EAST GOSHEN TOWNSHIP PLANNING COMMISSION

Tuesday, October 27, 2026, at 7:00 PM

Re: Campbell, 1409 Manley Road
Preliminary/Final Minor Subdivision & Land Development Plan Review

Date: October 22, 2026
To: East Goshen Township Planning Commission
From: Kelly A. Krause, Zoning Officer
Re: **Preliminary/Final 3-Lot Subdivision Plan**
1409 Manley Road/Campbell
Plans dated 8/1/2026, last revised on 10/4/2026

SCALE: 1"=20'		DRAWING NAME: 407-1409 MANLEY RD-GO-.DWG	
DRAWN BY: G.S.M.		DESIGNED BY: G. MAALOUF	CHECKED BY: G. MAALOUF
DATE: 8-1-2026	COMM. NO.: 2025-407	LAYOUT TITLE: C3	SHEET NO.: C3 OF 10.

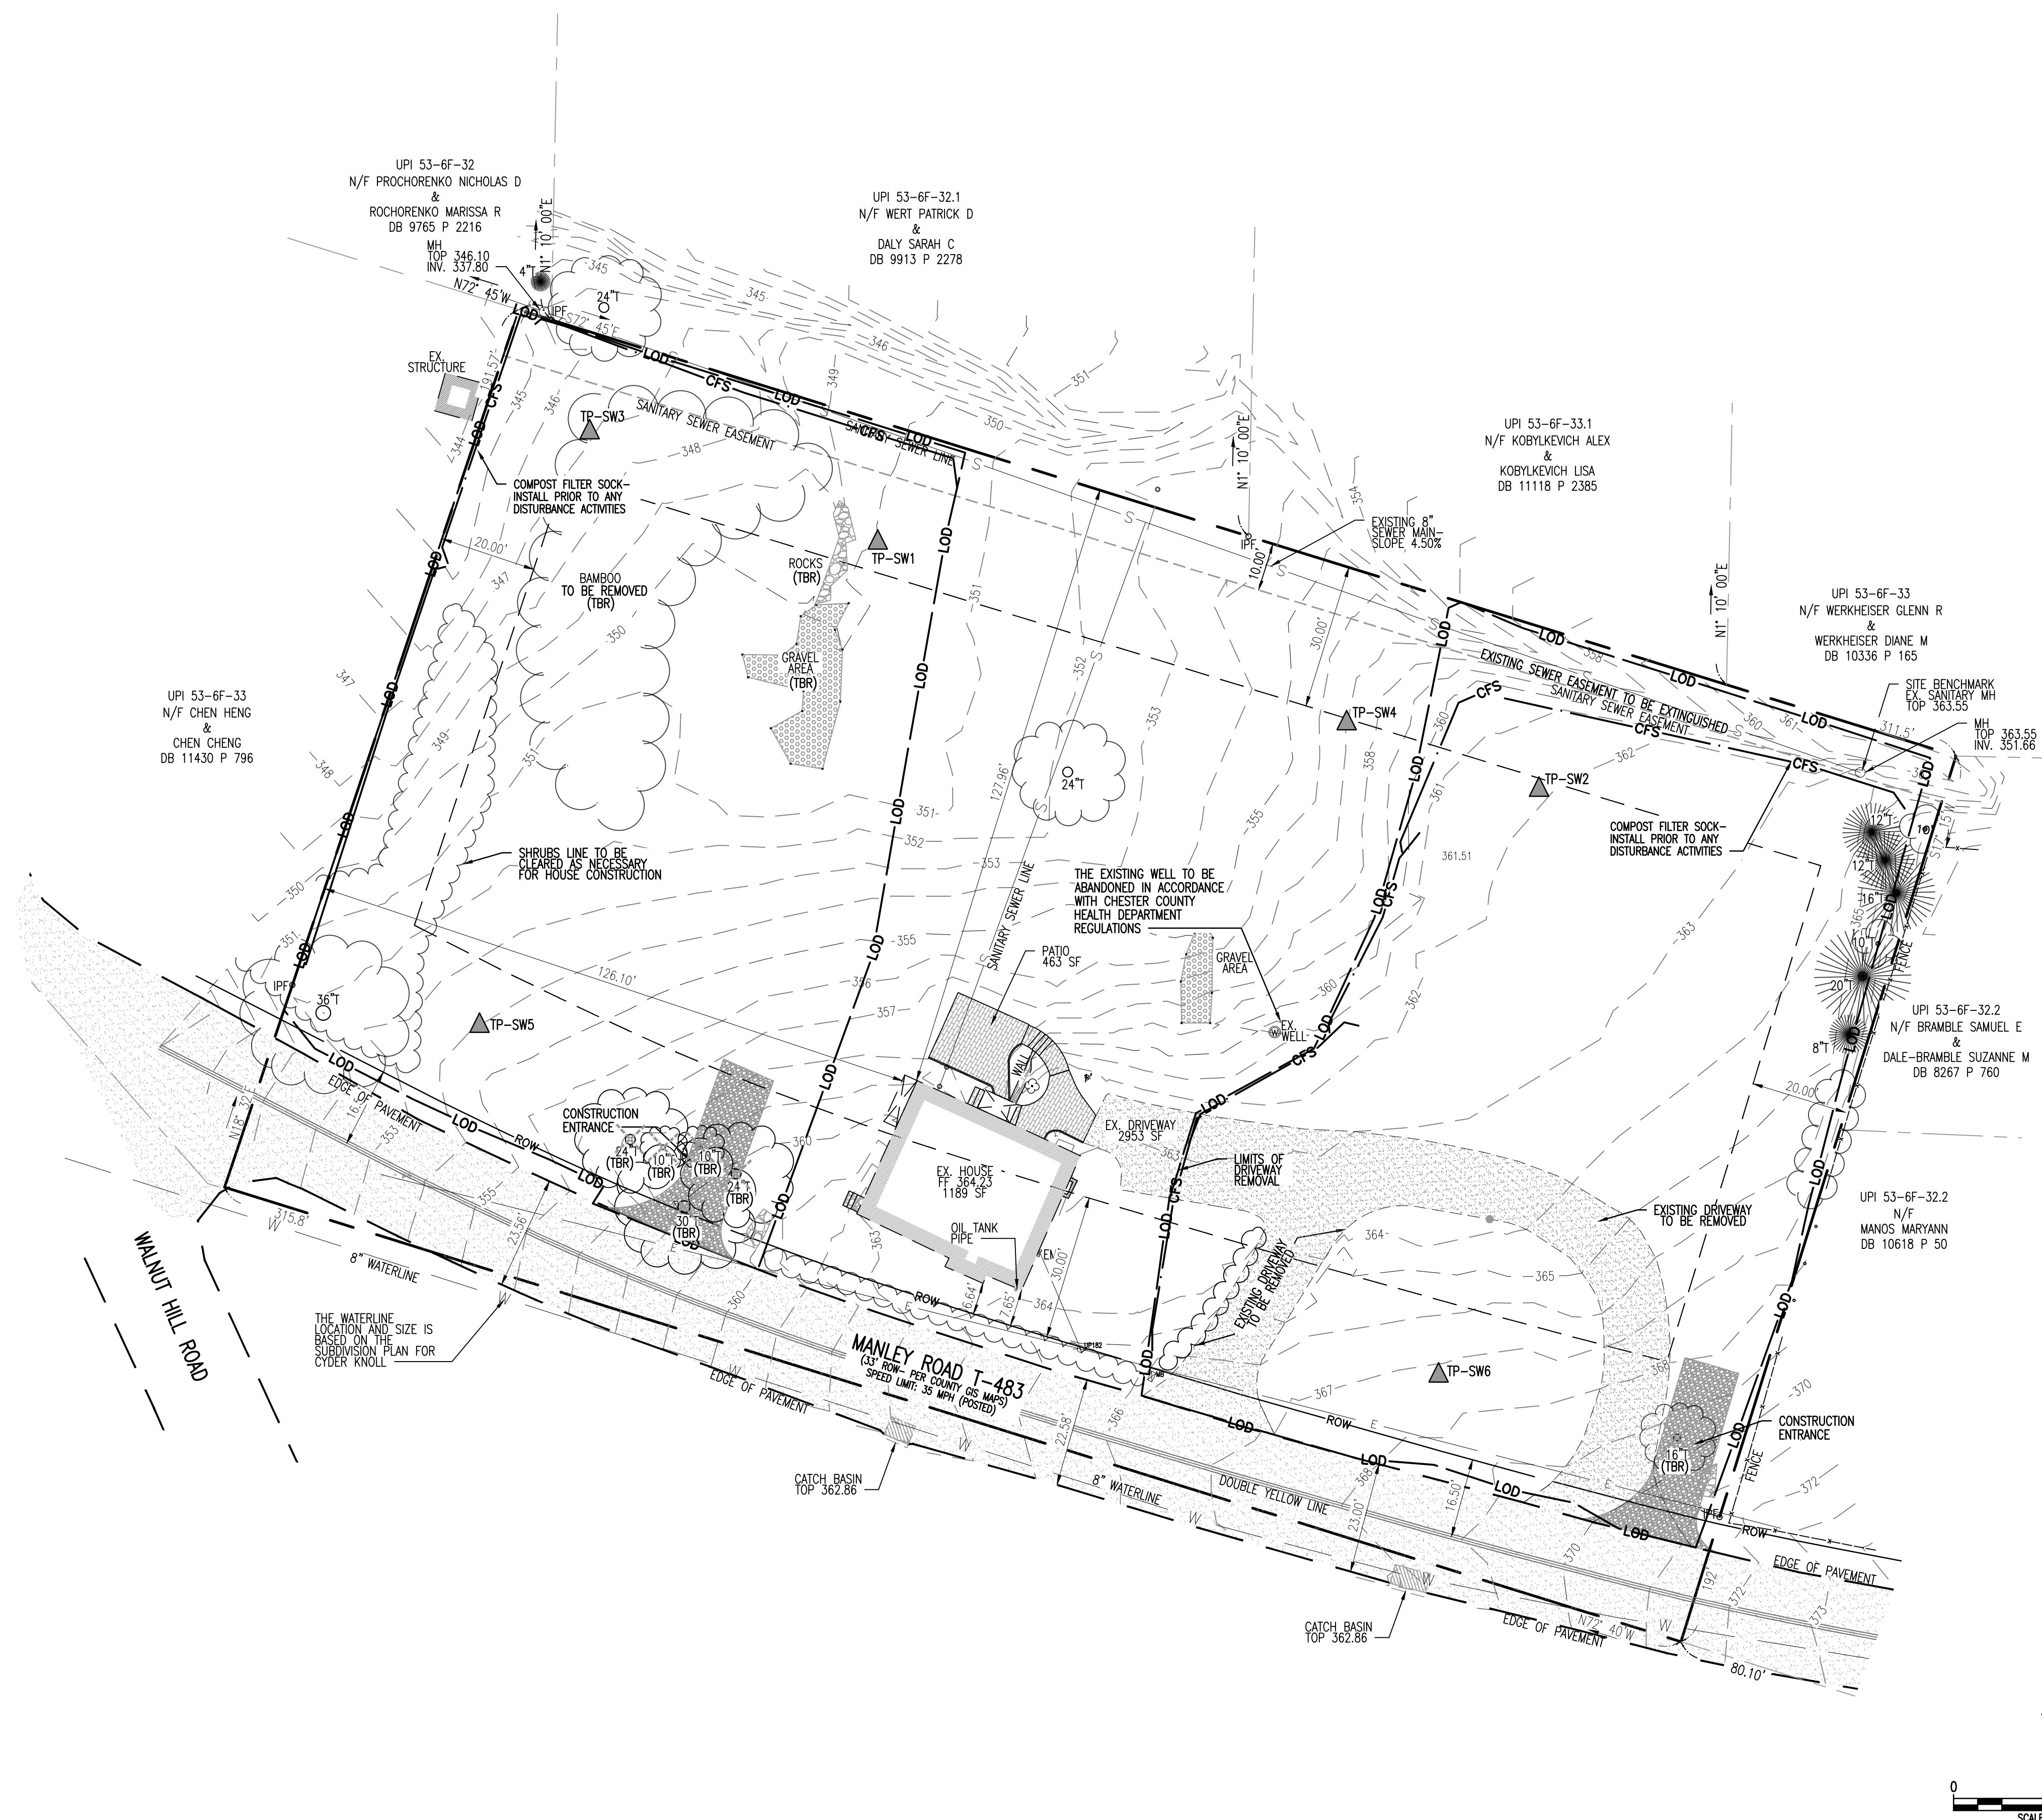
Response: A note has been added to revised sheet C6 to protect the existing trees as requested.

LANDSCAPE PLAN
SCALE: 1" = 20'

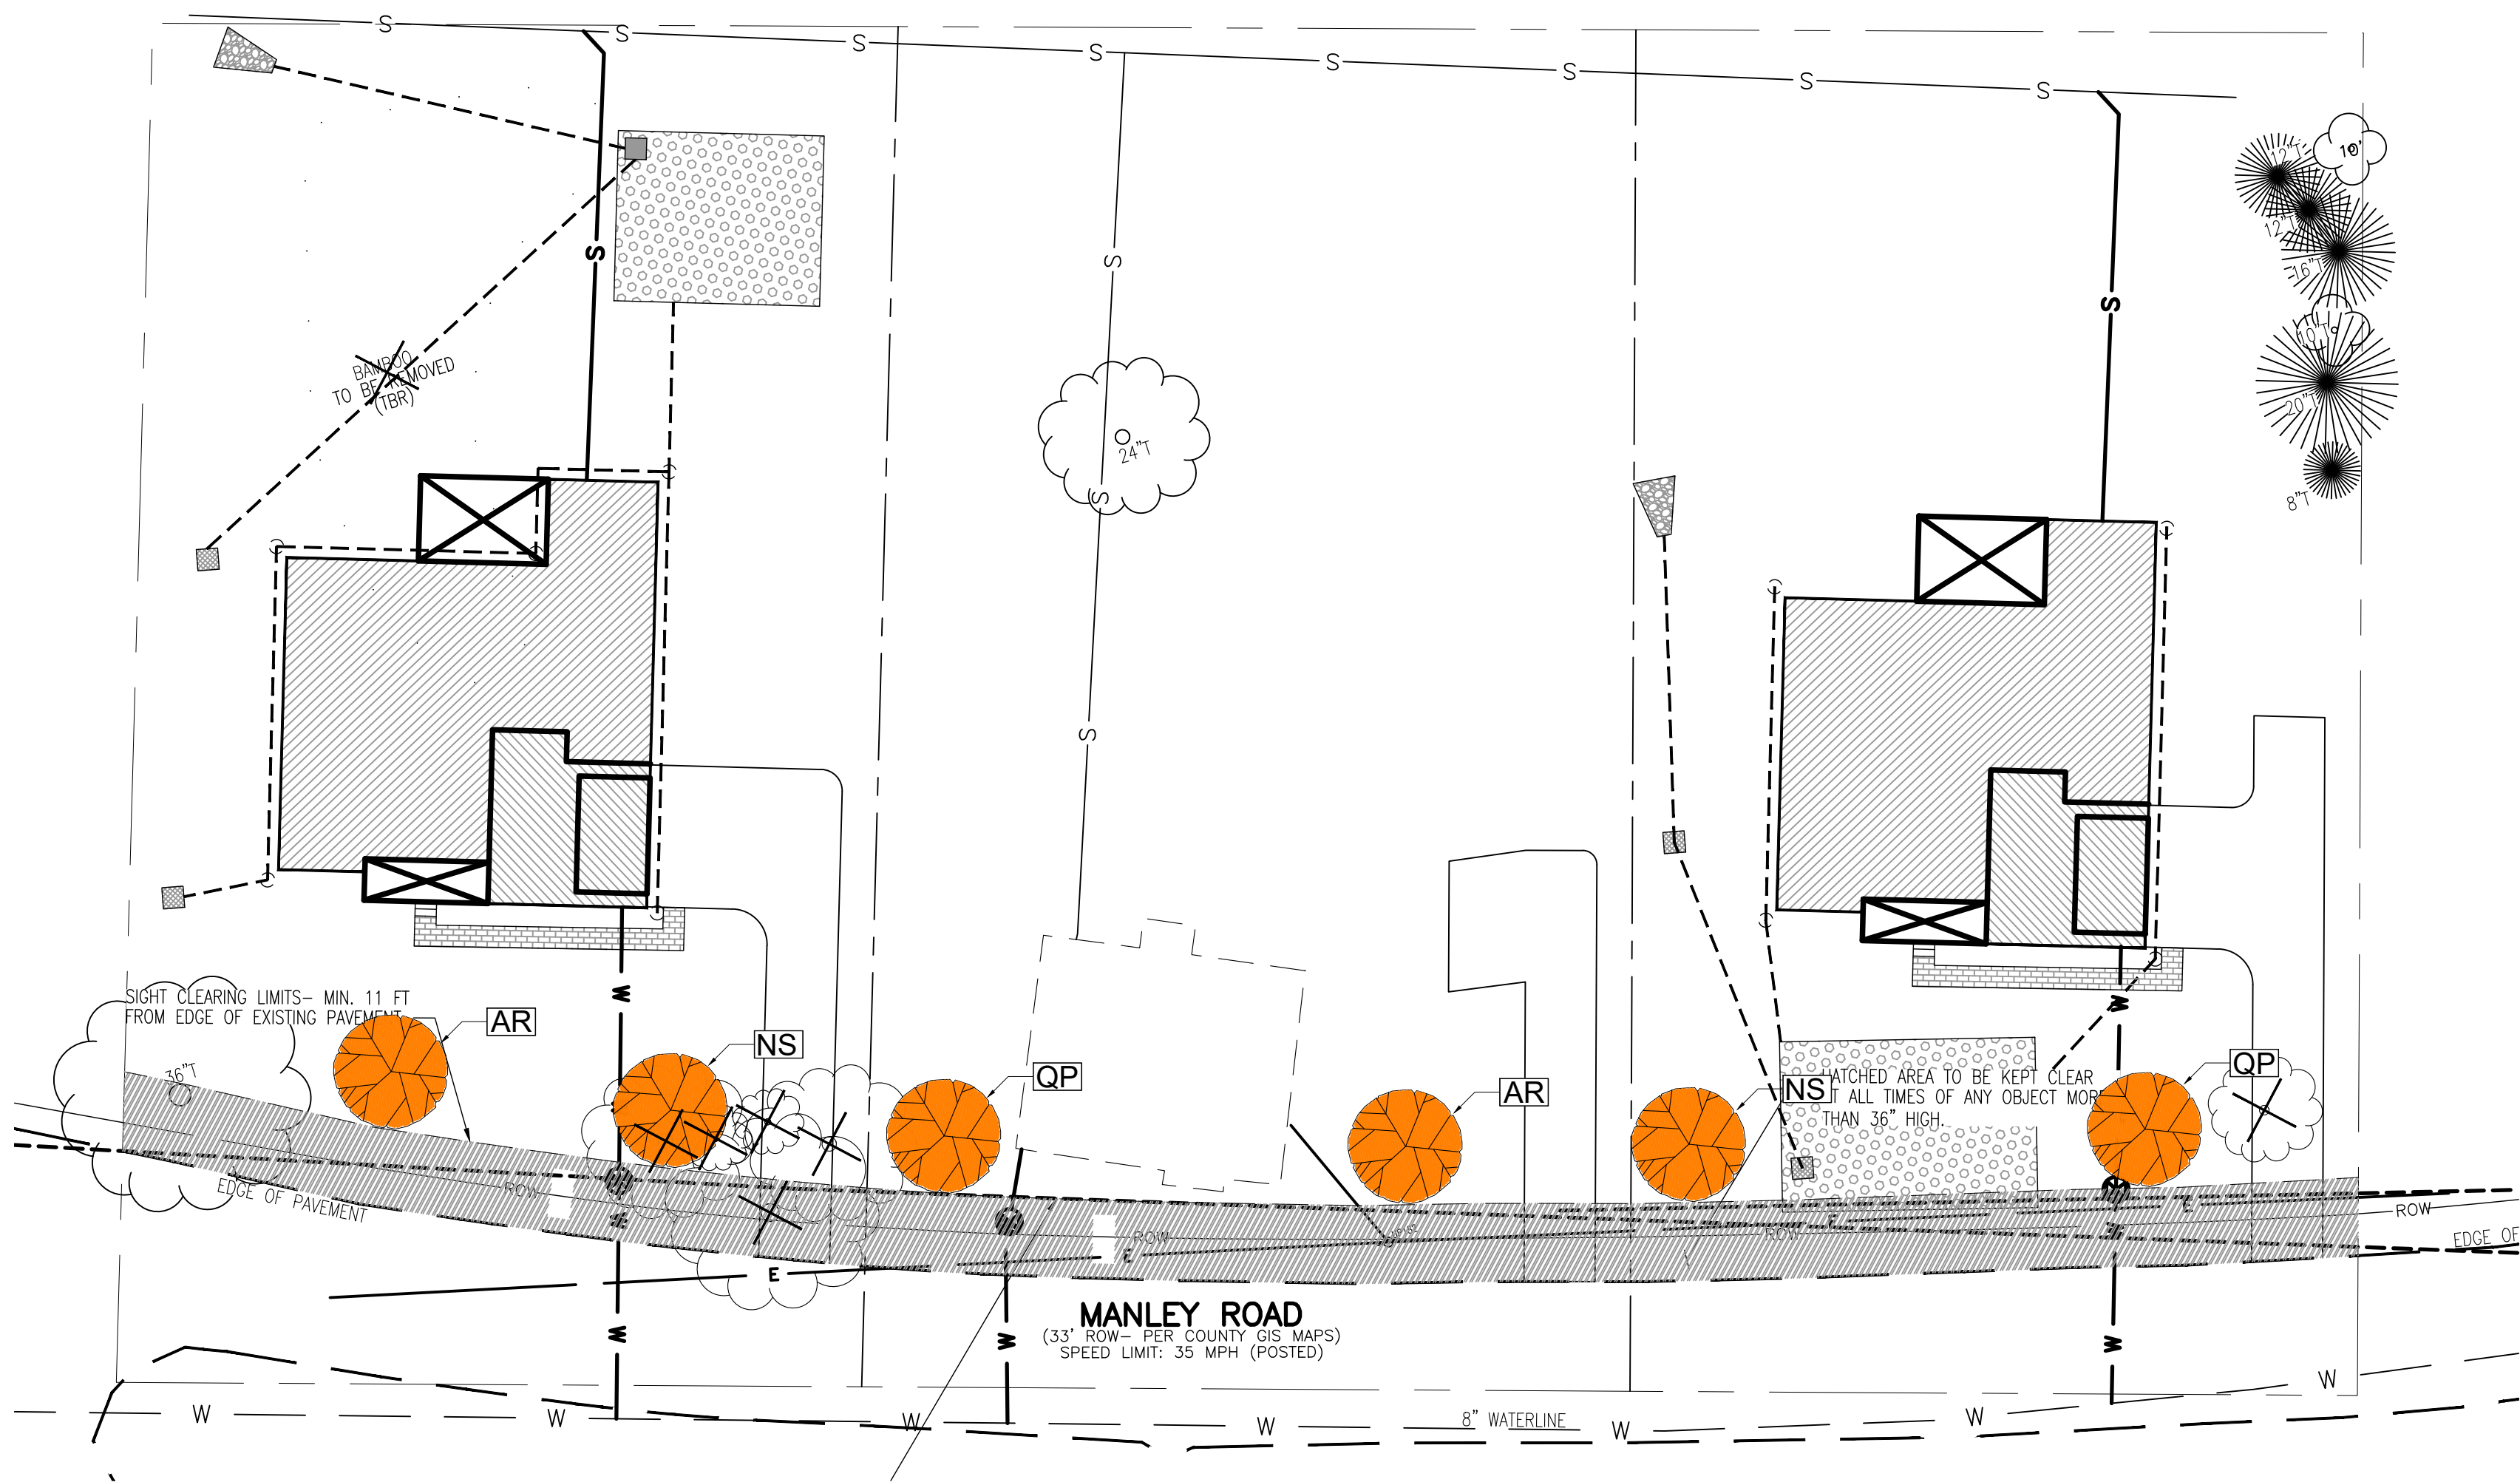
7. Preliminary and final plans shall include a landscape plan. (§205-30.D, §205-33.D & E).

Response: A Landscape plan is included with this submission.

Site Plan Detail, Sheet 2: Preliminary/Final Subdivision - 1409 Manley Road

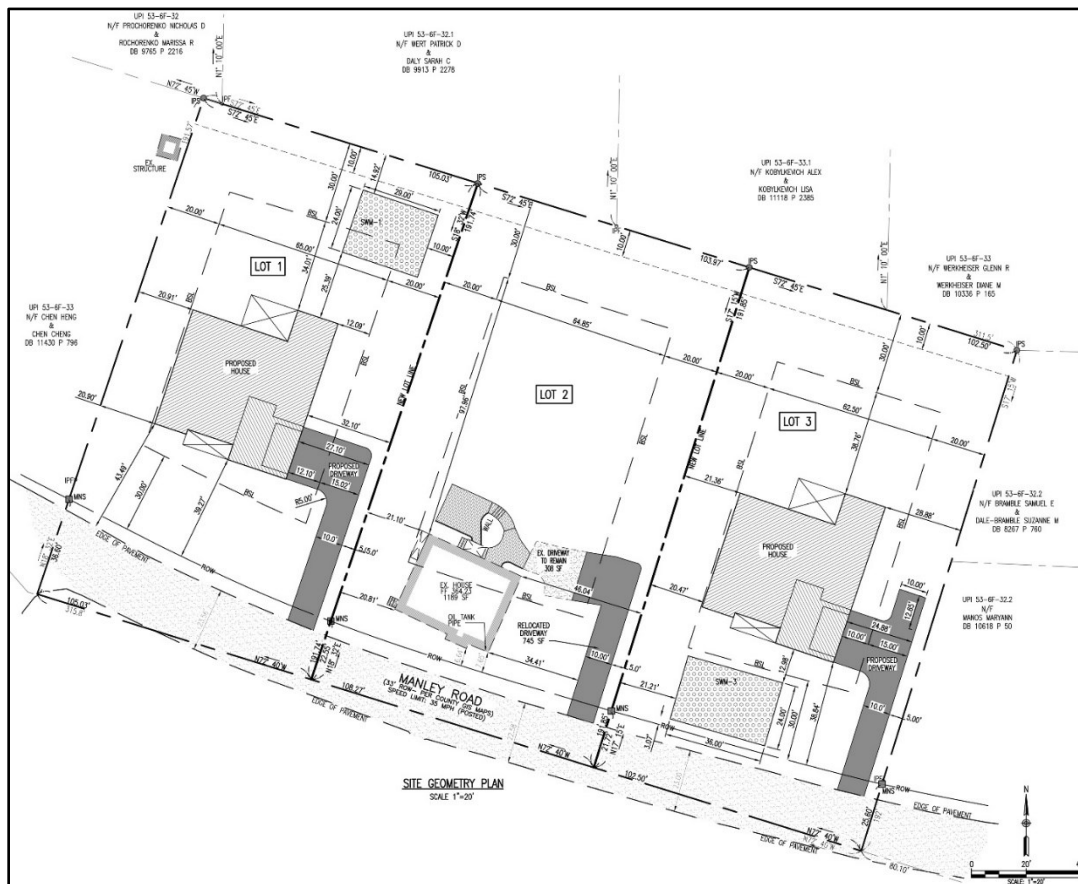
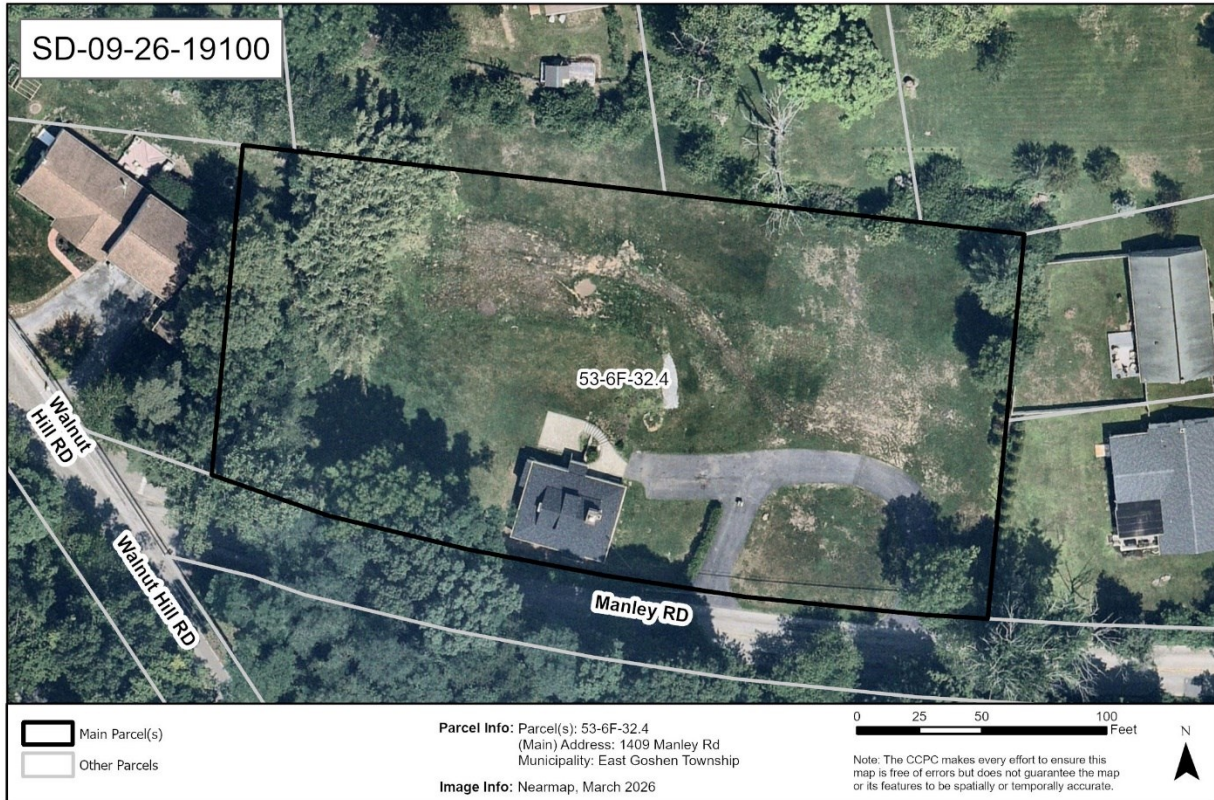
1. The project site is located within the **Suburban Landscape** designation of [*Landscapes3*](#), the 2018 County Comprehensive Plan. The vision for the **Suburban Landscape** is predominantly residential communities with locally-oriented commercial uses and facilities, accommodating growth at a medium density that retains a focus on residential neighborhoods, with enhancements in housing diversity and affordability. Additionally, roads, sidewalks and paths with convenient access to parks and community facilities should be provided. Furthermore, low to medium density mixed use development and infill development, community institutional uses such as schools and senior housing, and land available for new industrial and heavy commercial uses in appropriate locations, should be taken into consideration for planning activities in this designation. The proposed subdivision is consistent with the objectives of the **Suburban Landscape**.

2. *Watersheds 2045*, the County-wide integrated water resources plan and Act 167 Stormwater Management Plan, indicates the proposed development is located within the Chester Creek watershed. The *Watersheds 2045* plan's highest priority objectives within this watershed are: improving stormwater management to increase infiltration and protect baseflow; restoring stream channels and vegetated riparian corridors; addressing legacy and emerging contaminants; reducing nutrient pollution; and promoting source water protection methods. *Watersheds 2045* can be accessed at www.chesco.org/watersheds2045.

3. We suggest that, due to the site's proximity to Route 3 along with the recommendations provided in the County Planning Commissions' Active Transportation Inventory (ATI) municipal report for the Township, the applicant dedicate the land up to the ultimate right-of-way line for both roadway and potential sidewalk improvements. Sidewalks are an essential design element in the **Suburban Landscape**.

4. The plan and 2026 aerial photography indicate that a portion of the site is wooded. Given the project's location in a watershed designated as Trout Stocking and Migratory Fishes, the applicant should minimize the removal of trees on the property to the greatest extent possible to reduce the volume of stormwater generated and to preserve in-stream temperatures that support trout and other aquatic species. The "limits of disturbance" should be delineated to protect all trees that are intended to remain, and orange construction fencing should be placed at the "limit of disturbance" to prevent unintended intrusion into these areas by construction equipment. Additional native trees and shrubs should be provided to replace and mitigate the loss of removed trees.

Site Plan Detail, Sheet 2: Preliminary Subdivision - 1352 Morstein Road

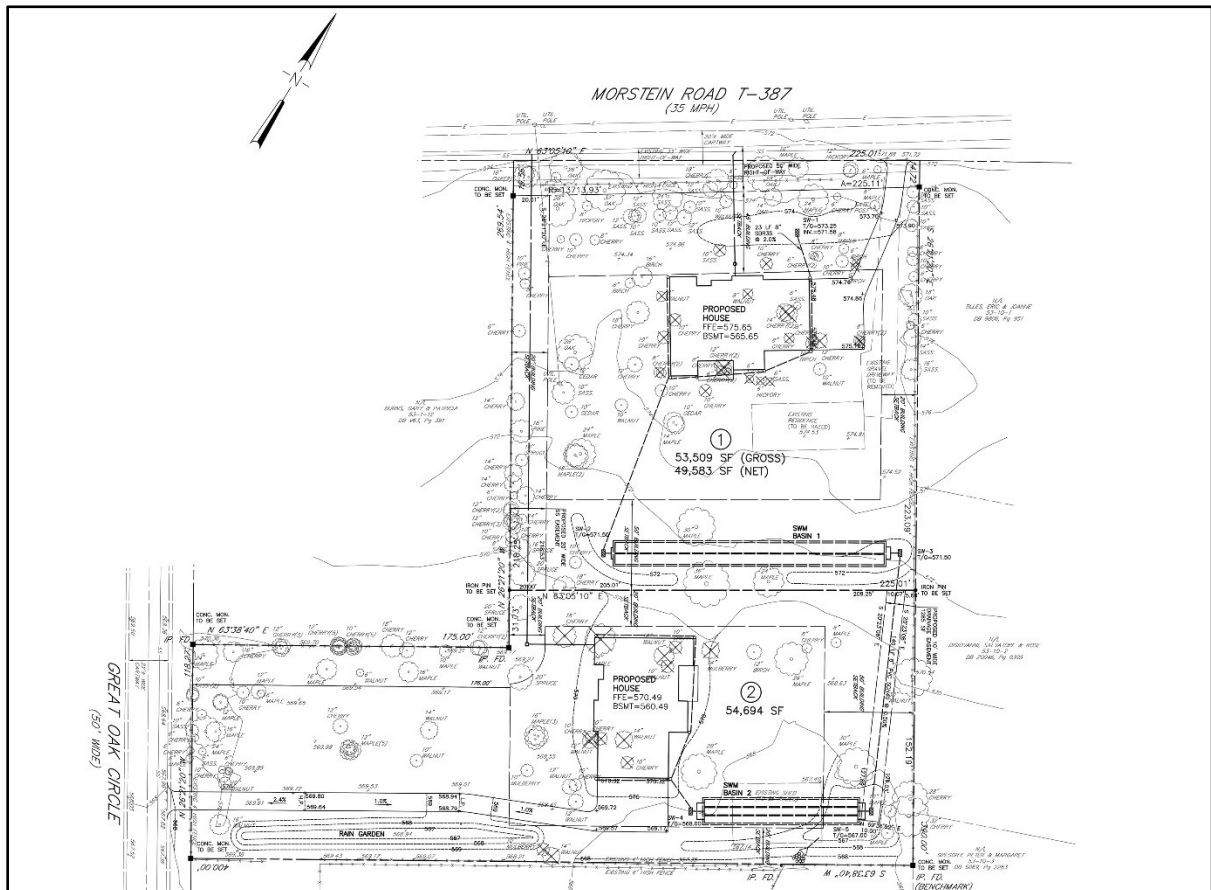
5. The Post Construction Operation & Maintenance Notes table on Sheet 6 indicates that the maintenance of the permanent stormwater management facilities, which include a rain garden on Lot 2, shall be the responsibility of the individual lot owner. Ongoing efforts by the municipality may be needed to educate the homeowners so that they can fully understand and fulfill the operation and maintenance requirements for these facilities, particularly in regard to the on-going maintenance of the rain garden plantings.
